**From:** Davis, Brian  
**Sent:** Wednesday, August 12, 2015 4:18 PM  
**To:** Grace Bryan  
**Cc:** Wagner, David B (PDS); Webster, Angela; 'jseabolt@michaelsinc.com' (jseabolt@michaelsinc.com)  
**Subject:** Re: 15Zone1015 - Signs posted for the Zoning Meeting - All are down  
**Attachments:** image1.JPG; image2.JPG; image3.JPG; image4.JPG

**10509 Bardstown Bluff – Proposed Zoning from RR to R-5A impacting Floyds Fork Creek** This proposal impacts all who visit the park and will be seen by all Jefferson County Residents as well as outside visitors. This proposal has major impact to Floyds Fork environment, the future Rental Residents, as well as joining properties.

**Re: Change in zoning from RR Rural Residential to R-5A Multi-Family Residential to allow a patio home community to be located on 34.16 +/- acres on the east side of Bardstown Road at 10509 Bardstown Bluff Road to be known as "Brentwood Commons"**

April 2015 picture of 10509

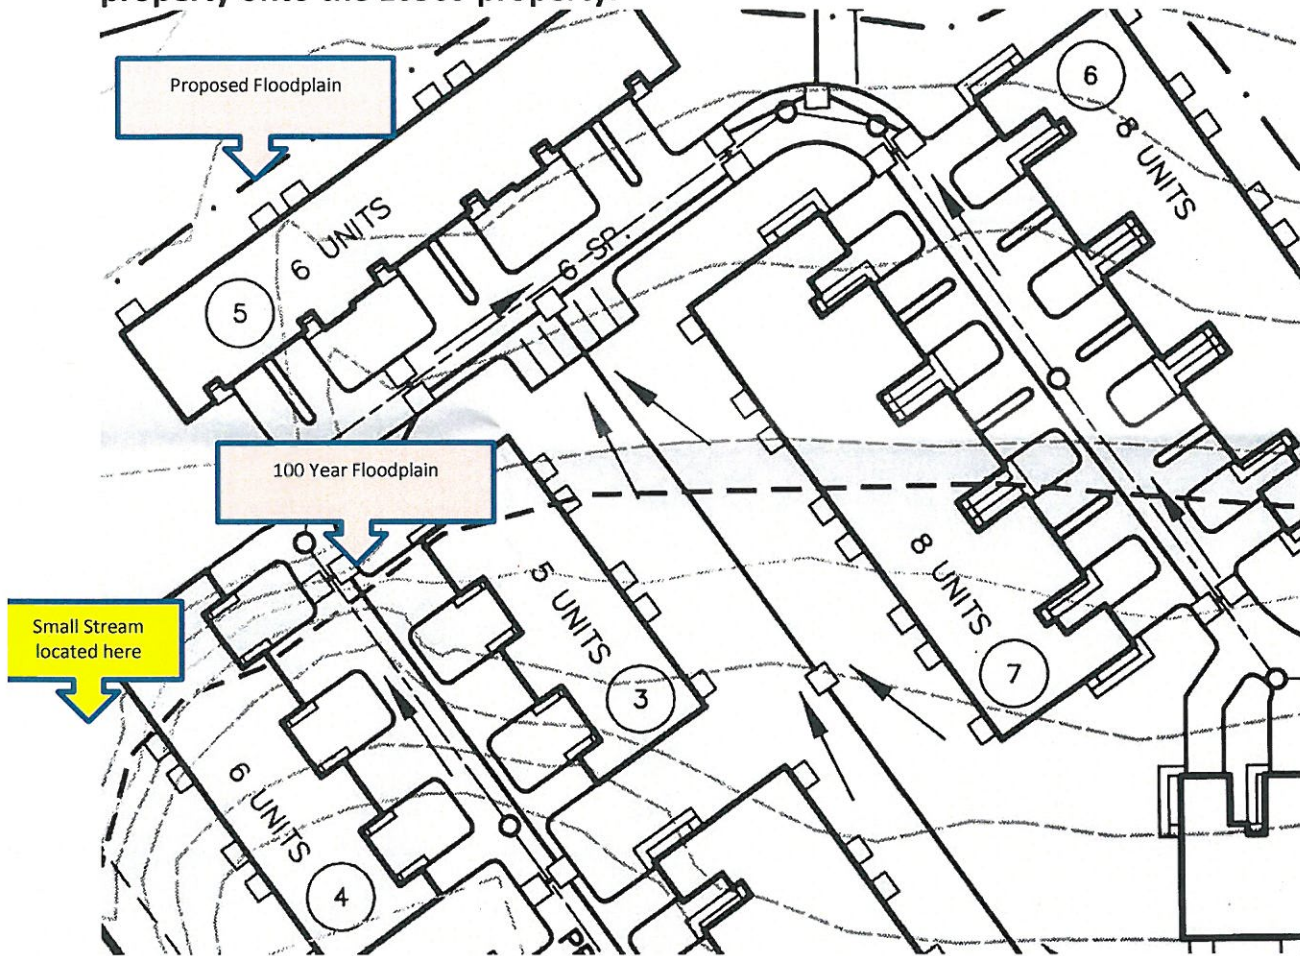
Units are being built in this water location

#3, 4, 5, 6 and 7 buildings, 33 Apartments to be built in flood area. Flooding has occurred in 1997, 2009, 2011, 2013, and 2015. Flooding is more frequent as subdivisions are built closer to the Floyds Fork. **Yellow note** displays location of the small stream running from the 10505 property onto the 10509 property.

Below is an April 2015 picture of the small stream (not so small during flooding) on the 10509 property.

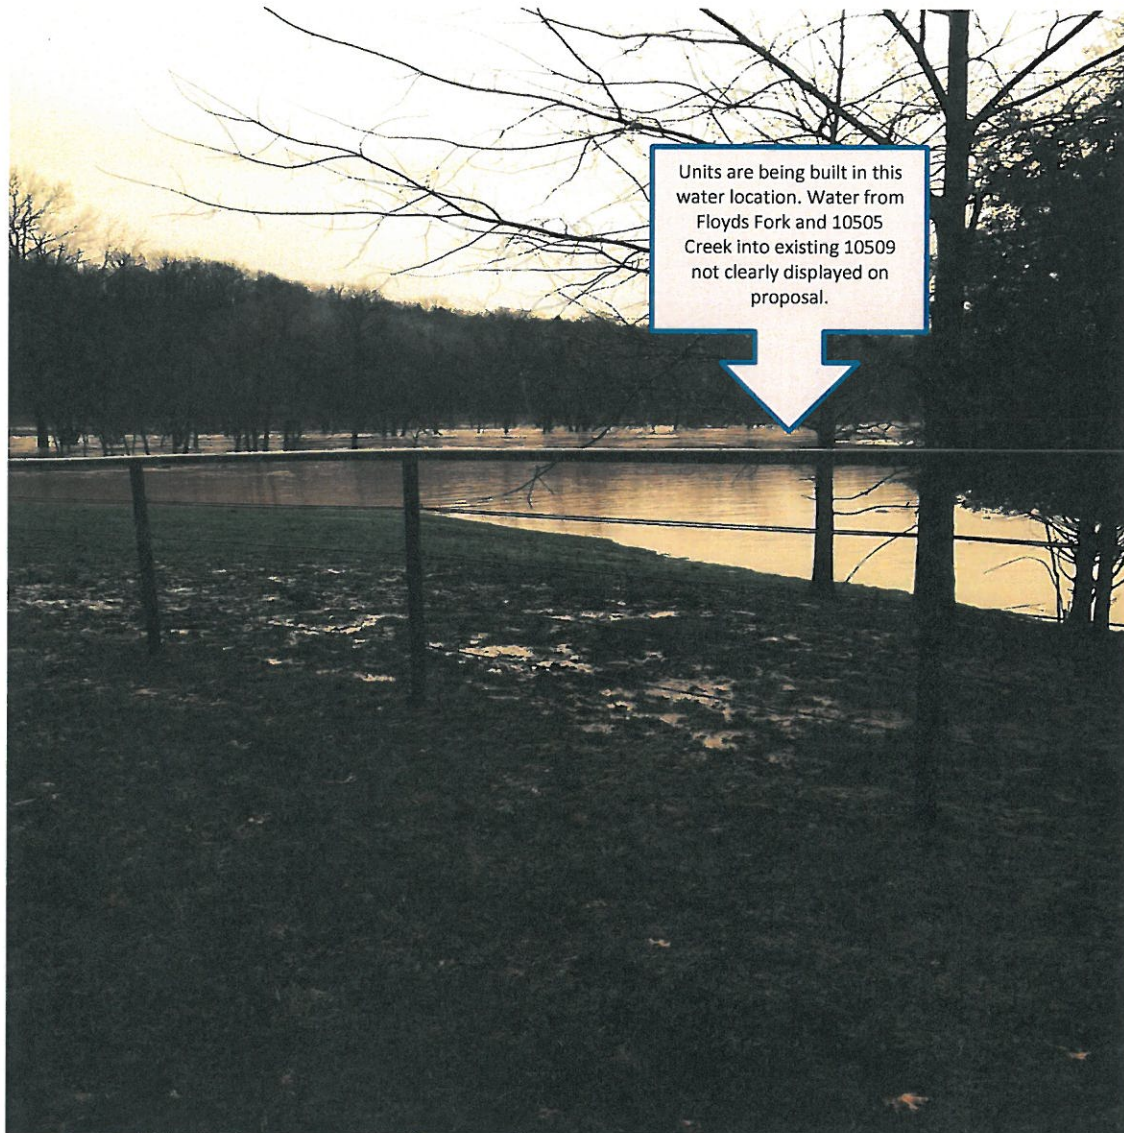
Units are being built in this water location. Water from Floyds Fork and 10505 Creek into existing 10509 not clearly displayed on proposal.

Below April 2015 picture is of the small stream on the 10509 property. The Parkland Bridge is in the background.

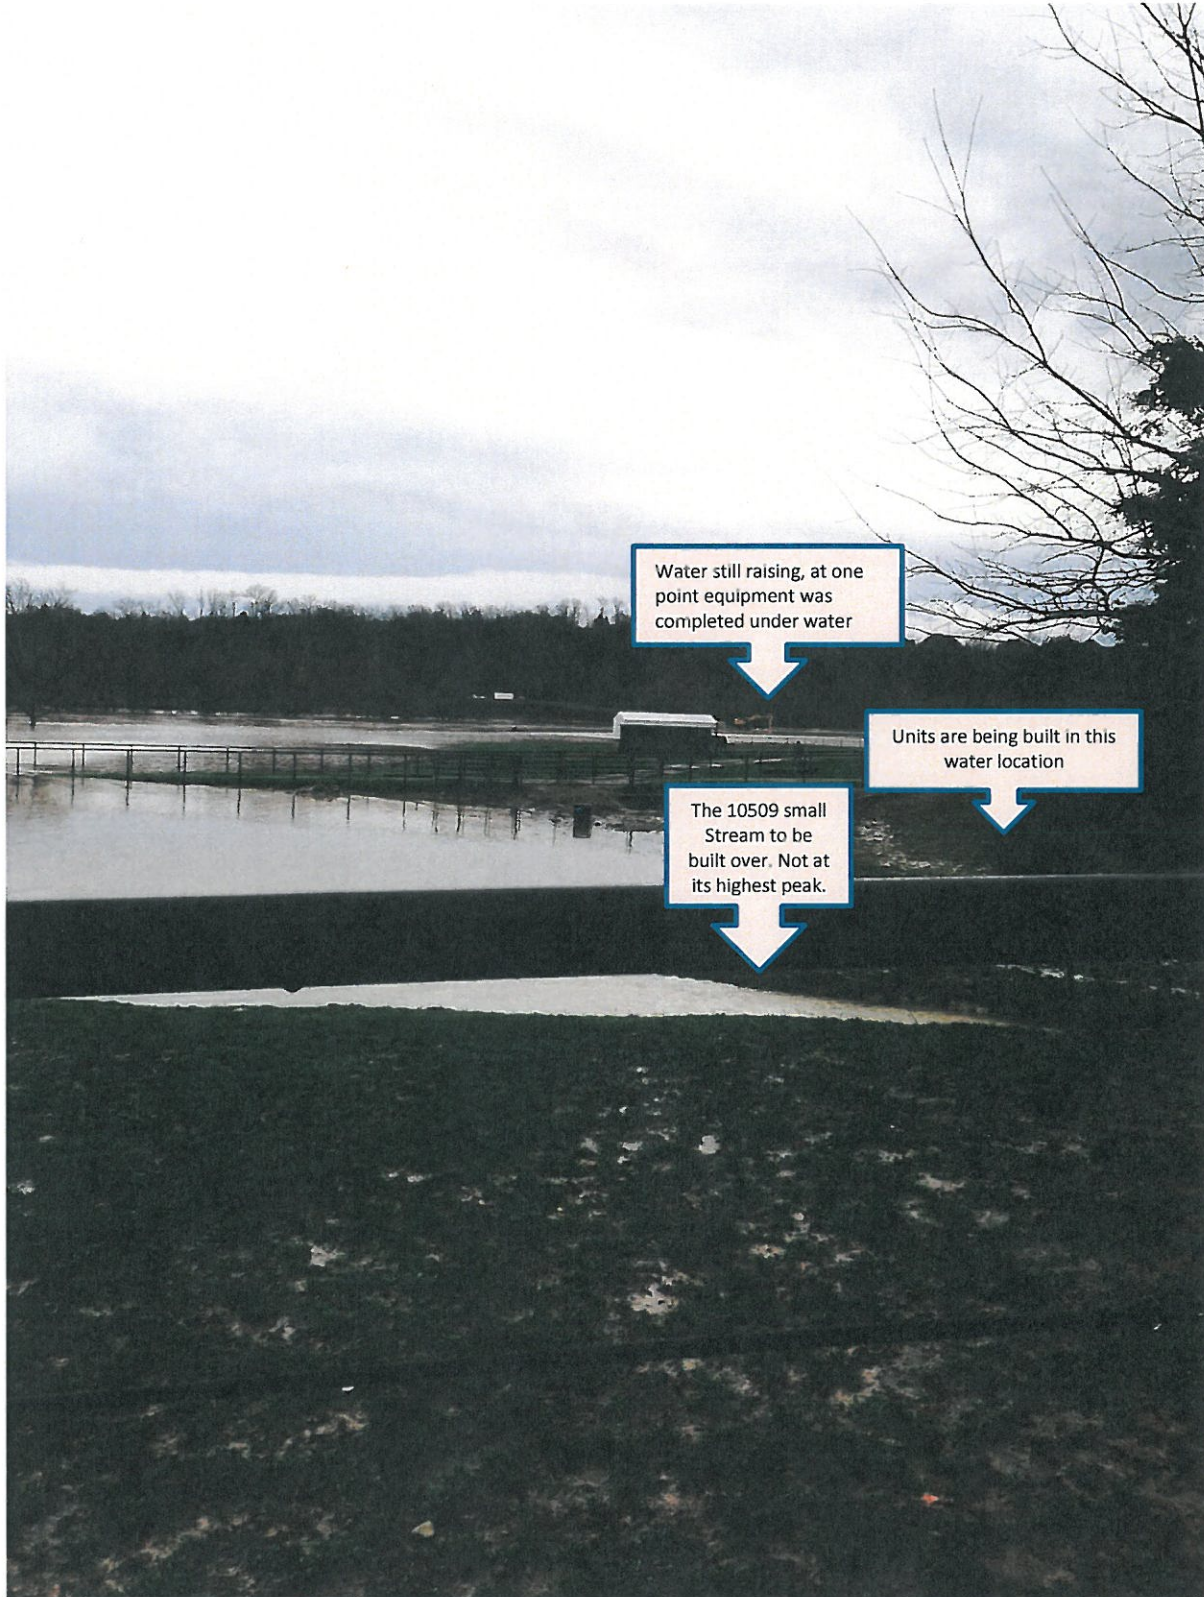
Water still raising, at one point equipment was completed under water

Units are being built in this water location

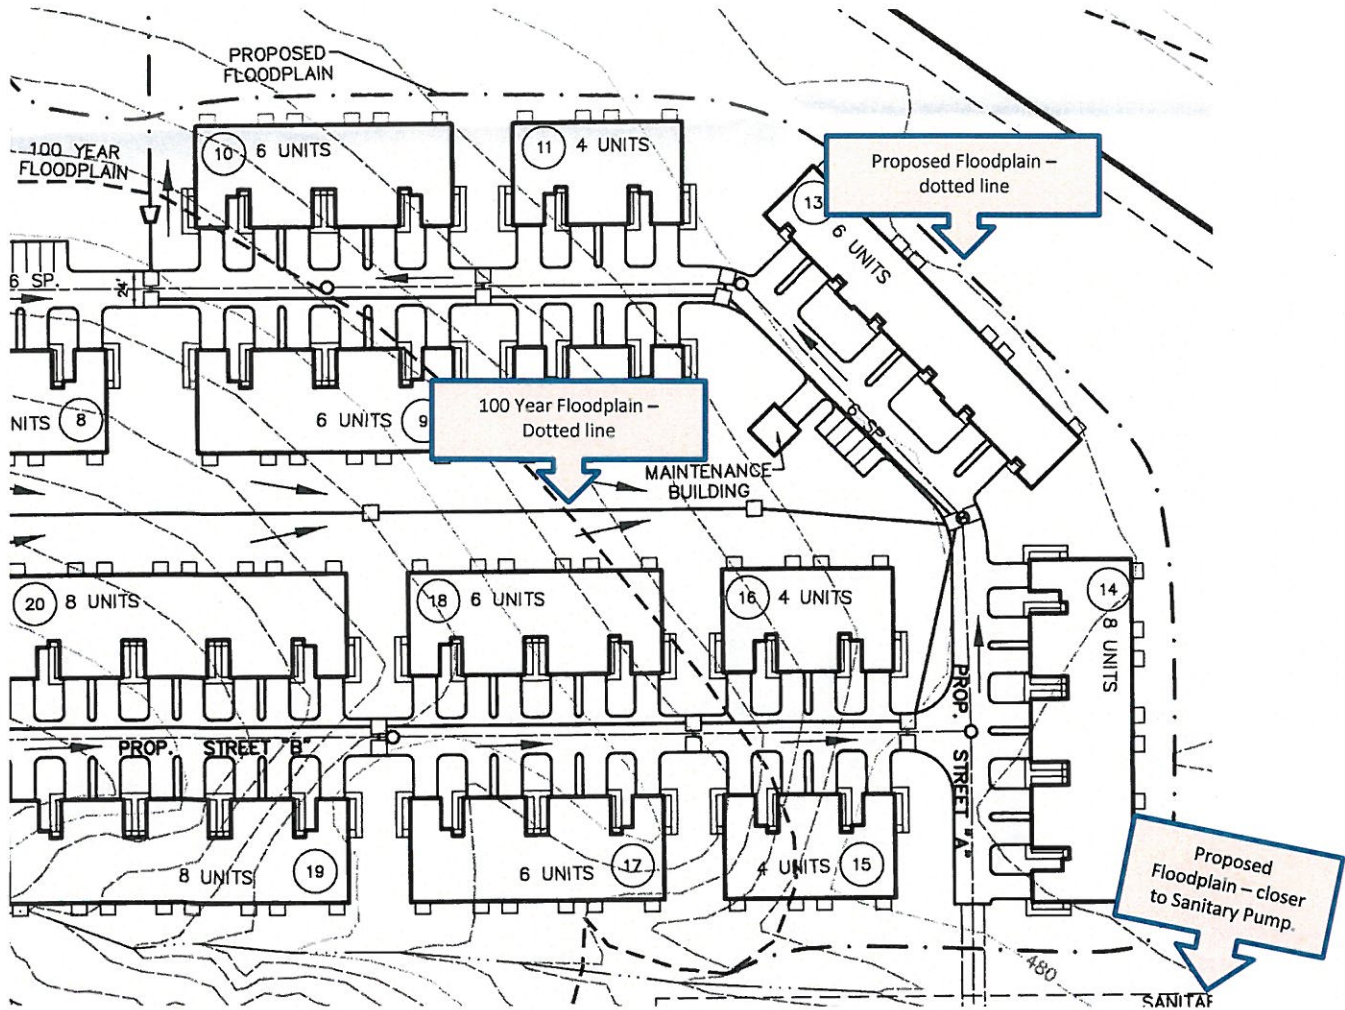
Large distance between the 100 Year Floodplain to the Proposed Floodplain. For approximately the last 20 years every 5 years the property has been flood past the 100 Year Floodplain.

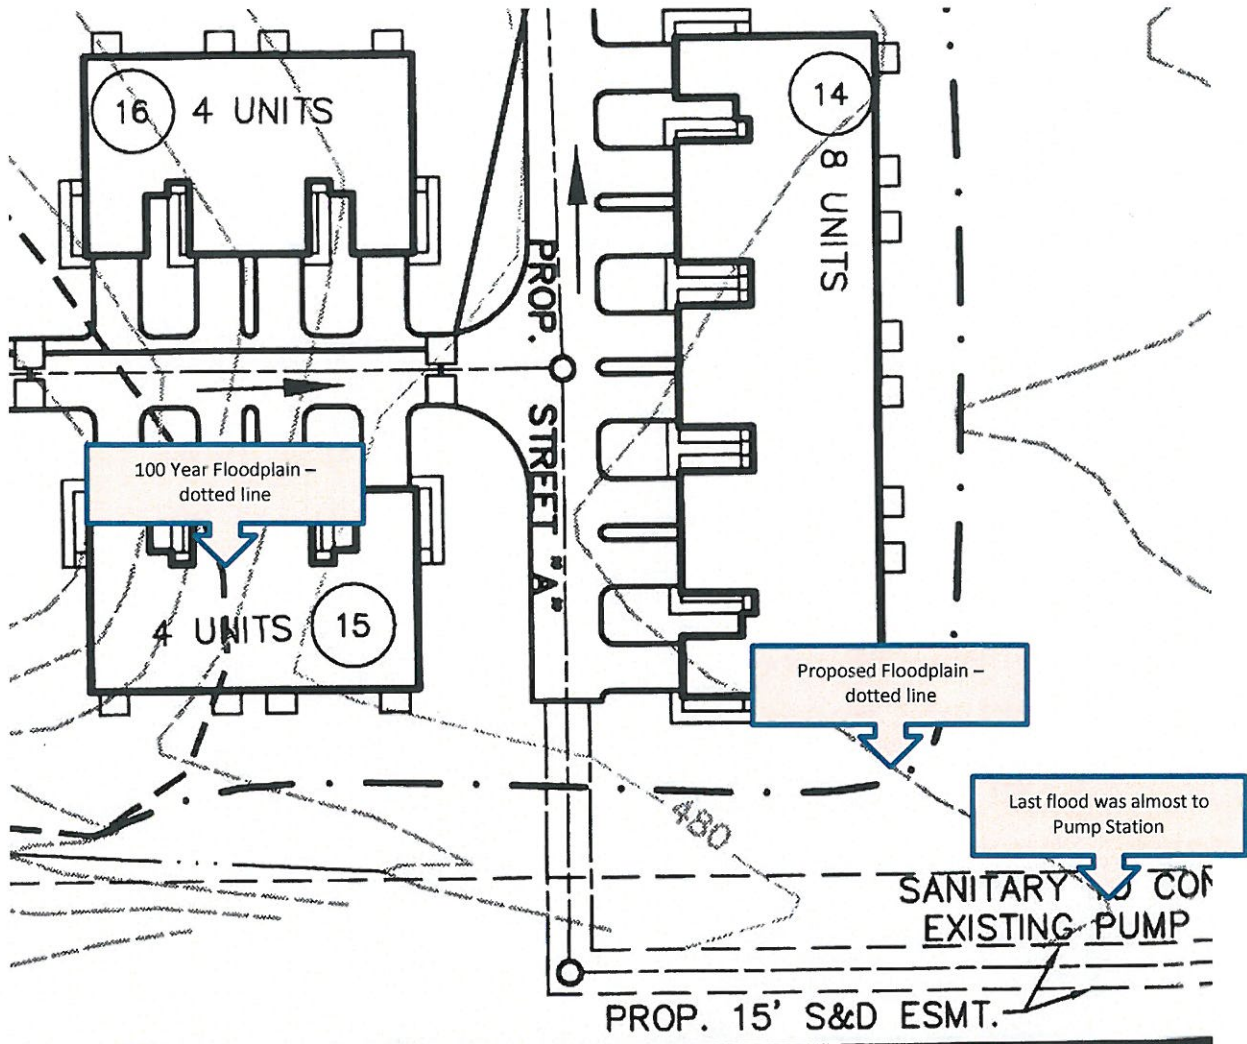
Proposed Floodplain is closer to the Sanitary Pump Station than the 100 Floodplain. 2015 Flood came dangerously close to the Pump Station, now they are proposing a closer Floodplain.

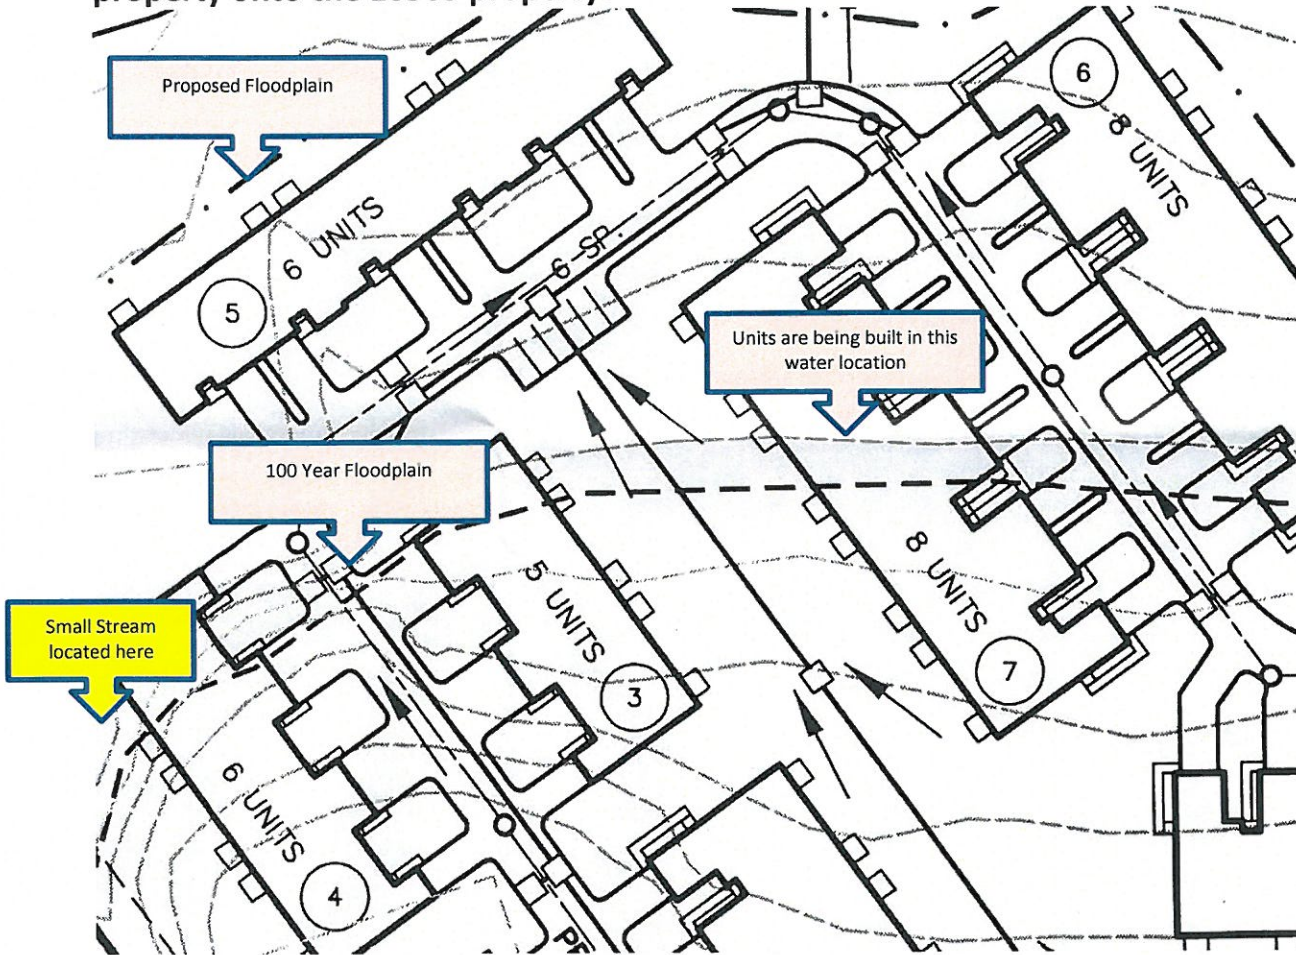
#3, 4, 5, 6 and 7 buildings, 33 Apartments to be built in flood area. Flooding has occurred in 1997, 2009, 2011, 2013, and 2015. Flooding is more frequent as subdivisions are built closer to the Floyds Fork. **Yellow note** displays location of the small stream running from the 10505 property onto the 10509 property.

Below April 2015 picture is of the small stream on the 10509 property. The Parkland Bridge is in the background.

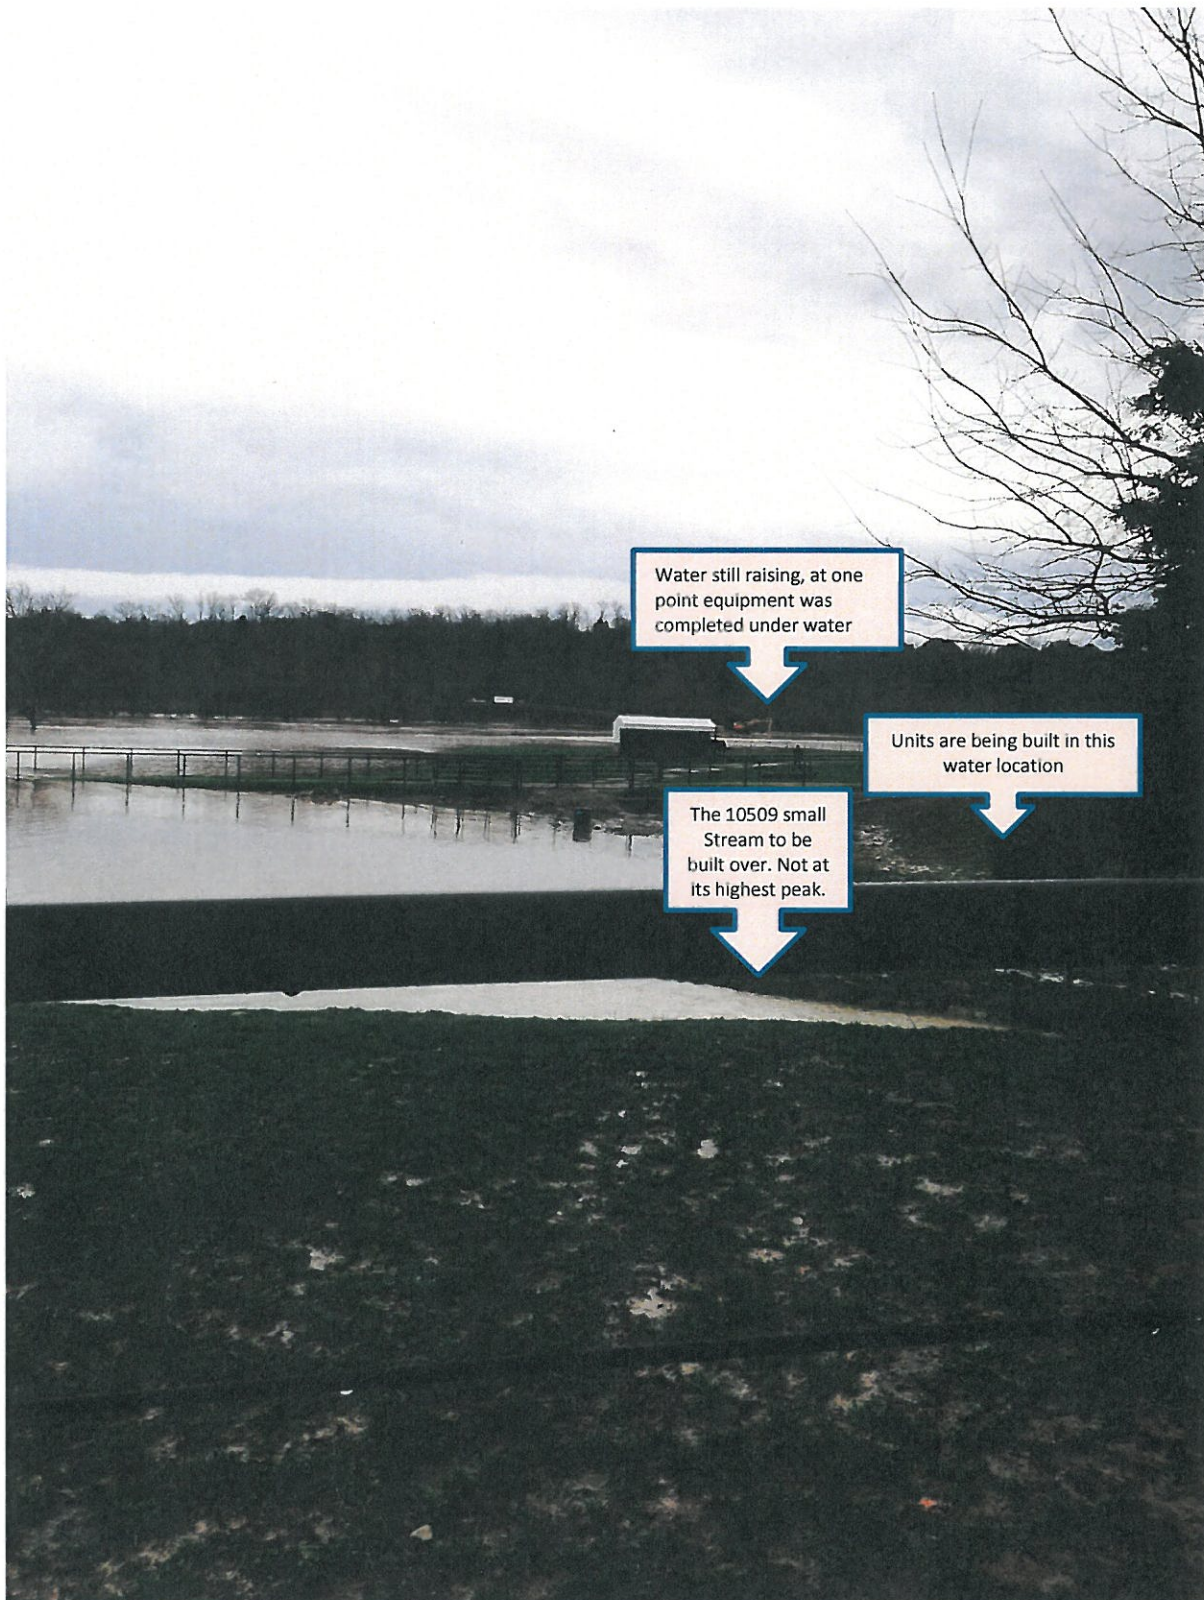
Units are being built in this water location. Water from Floyds Fork and 10505 Creek into existing 10509 not clearly displayed on proposal.
